Access Compliance Report

Public Rights-of-Way

| Intersection ID: 14085 | Main Street: CARLTON_AV | Cross Street: MT_VERNON_AV | Location: SE |
| ADA ID: DF21CA303254 | Ramp Type: Perp | Initial Pass/Fail: Fail | Overall Compliance: No |

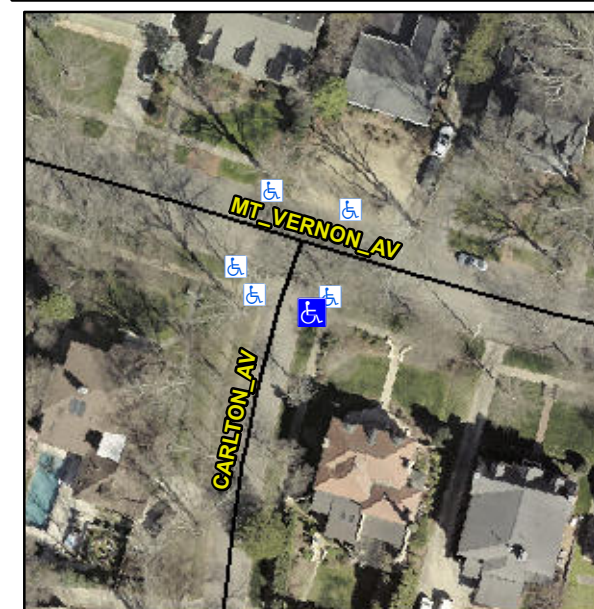
Not Found, R304.5.1, R304.5.3

| Compliance | Description | Data | Compliance | Description | Data |
|------------|-----------------------|------|------------|-----------------------------|------|
| No | Ramp Width (in) | 45.0 | No | Ramp XSlope (%) | 6.8 |

Remove & Replace Entire Ramp.
